Re: Interpretation for RZ 86-C-021 and CP 86-C-121-4, Reston Target, Tax Map 17-3 ((1)) 33,
33A: Target expansion

**RE: Reston Target Store T-1088 (County #9153-SP-01-2)
12197 Sunset Hills Road
Reston, Virginia
CEI Project #19071.0**

**RESTON GREATLAND - TARGET
 STORE # T-1088**

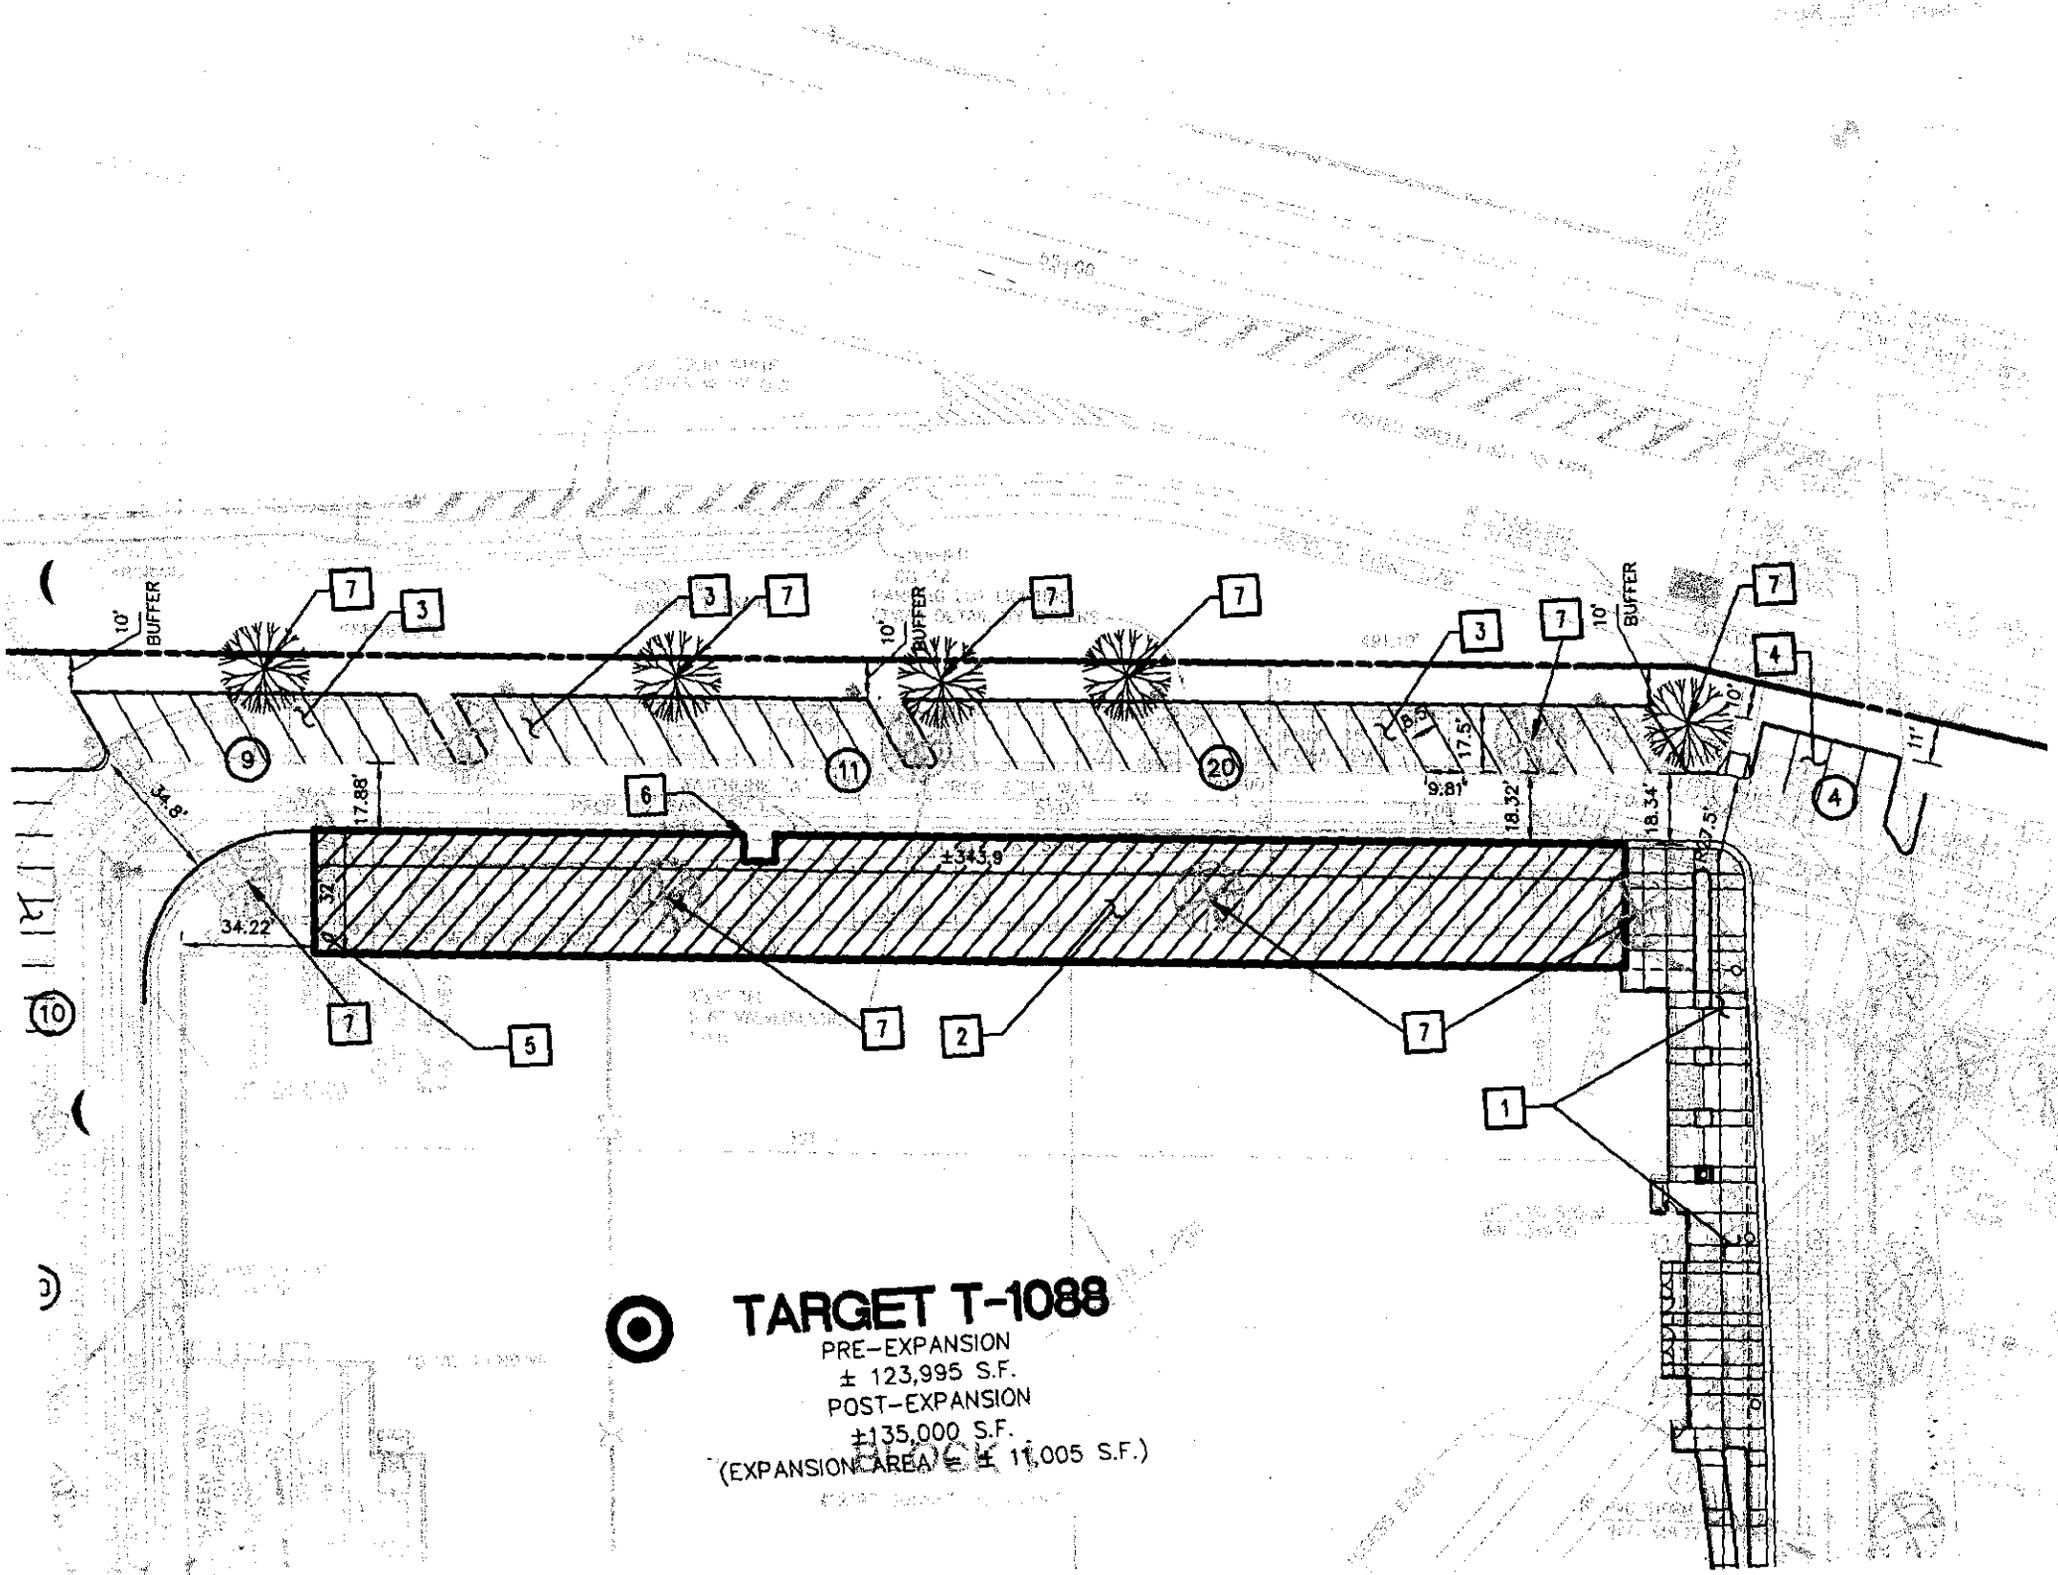
Your question, as I understand it, is whether the revised proposal described in your May 24, 2004, letter is in substantial conformance with the proffers, development plan, and the concept plan, CP 86-C-121-4. According to your letter, the proposed addition of 11,005 square feet would result in a total of 135,000 square feet of gross floor area, which is within the maximum permitted square footage of 135,000 square feet permitted for Target on the approved Conceptual Plan. The proposed addition would extend 32 feet from the northern side of the building which will eliminate approximately 37 parking spaces but, according to your submitted plan, parking will be provided at a ratio of 4.01 spaces per 1,000 square feet of gross square feet, which meets the Ordinance requirement and conforms with Note 6 of the approved Conceptual Plan. In addition to eliminating one row of parking, which was located adjacent to the northern edge of the building, the row of parking spaces which is located adjacent to Sunset Hills Road has been re-designed as 60° angle spaces and the curb located in the northwest corner of the parking lot has been straightened to accommodate the revised design. According to your letter and plan, the 60° angle parking spaces are 17.5 feet in length, instead of 20 feet, because you believe that a 2.5 foot overhang beyond the wheel stops can be allowed for this type parking. It is my understanding that

the Public Facilities Manual allows a 1.5 foot overhang, not 2.5 feet. It is also my understanding that a one-way travel aisle with 60° angle parking is required to be a minimum of 17 feet wide. The aisle depicted on your plan ranges from 18.32 feet to 17.88 feet in width. Therefore, it may be possible to correct this through final engineering; however, the issue will need to be resolved with DPWES during site plan approval. For your information, the ten (10) foot wide landscaping strip which is located between the angle parking spaces and the right-of-way of Sunset Hills Road is required by the Zoning Ordinance and must remain.

Your plan also shows that five (5) trees which were located in the footprint of the proposed building addition have been relocated to the ten (10) foot landscaping strip which lies between the parking lot and the right-of-way of Sunset Hills Road. It should be noted that all landscaping is subject to the review and approval of the Urban Forestry Division.

It is my determination that the proposed modified addition and parking lot re-design of the Target store are in substantial conformance with the proffers, development plan and CP 86-C-121-4, subject to a satisfactory resolution of the parking space overhang issue by DPWES. This determination has been made in my capacity as the duly authorized agent of the Zoning Administrator.

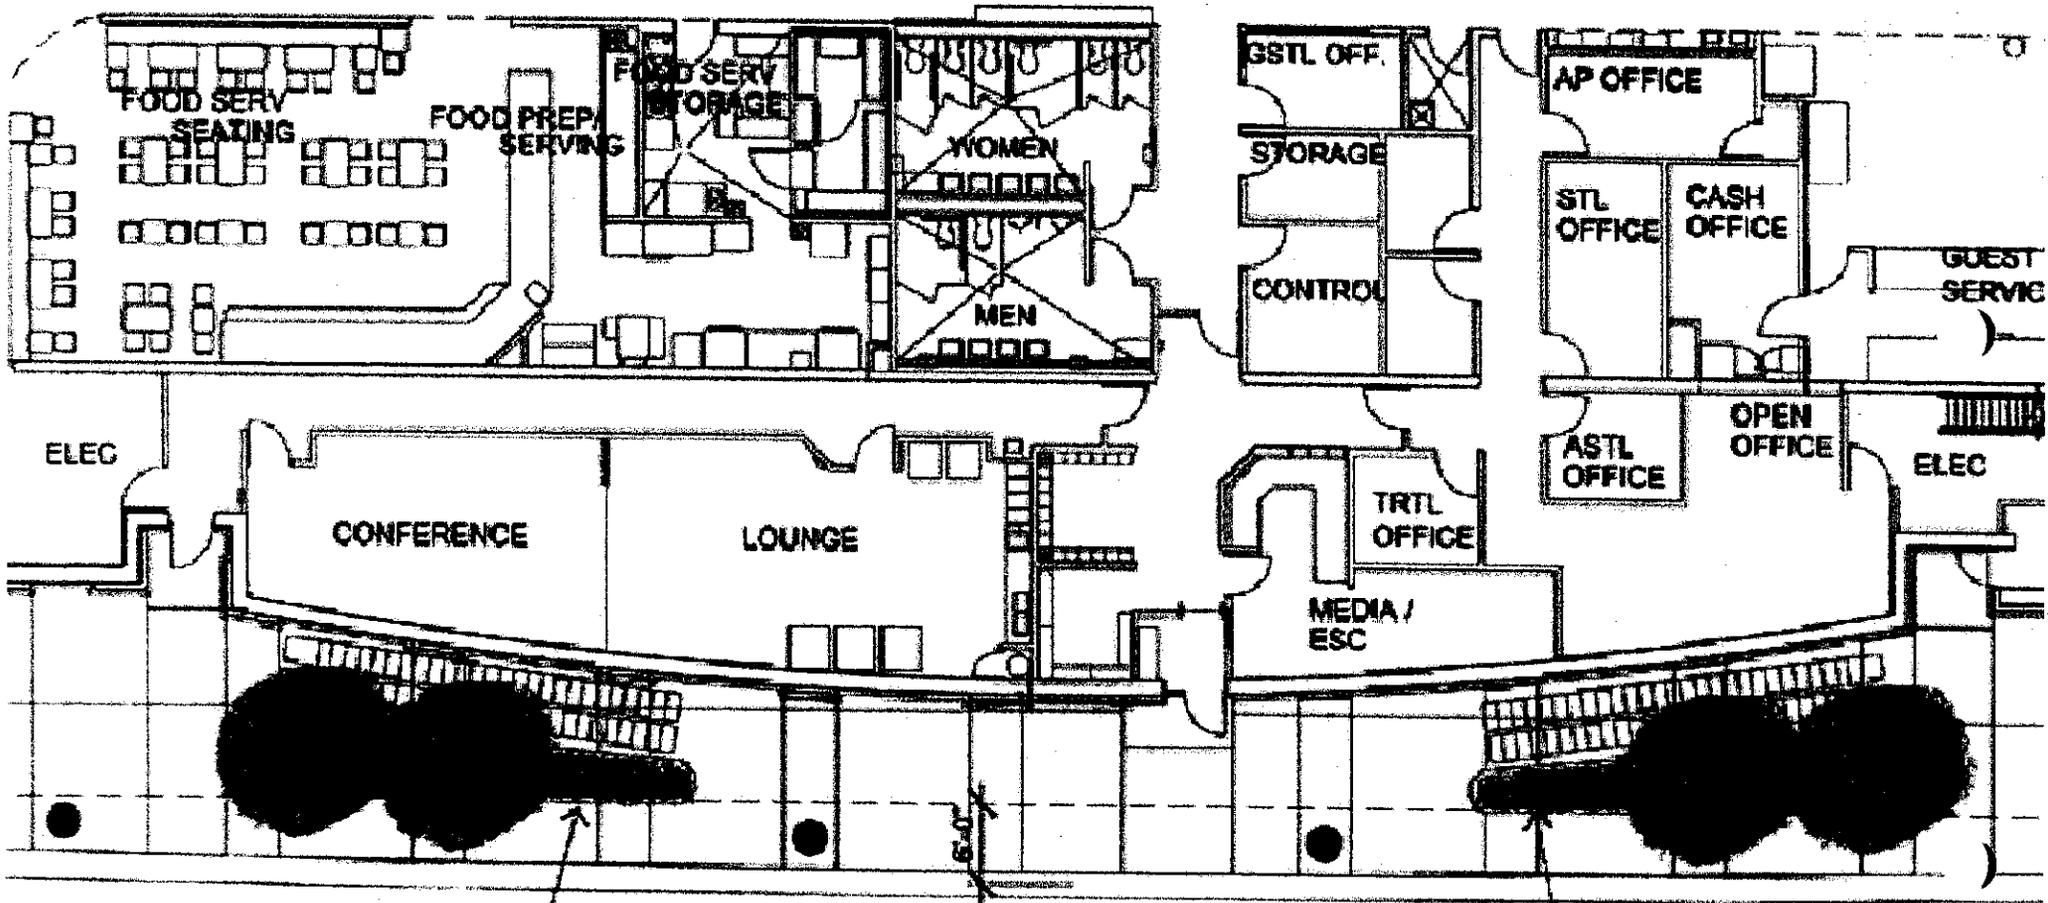
The Schematic Design Package shows a revised front elevation for the building and a floor plan for the proposed modified sidewalk area in front of the building. According to this design, hedges and ornamental trees will be added in two locations in front of the building to provide screening of the shopping carts. Hedges are proposed to be located in front of the building expansion. The depicted front elevation appears to be generally consistent with that shown on the approved concept plan; however, pursuant to Note 31 on the Conceptual Plan, landscaping, site design and architectural details are subject to final review and approval by the Reston Town Center Design Review Board.
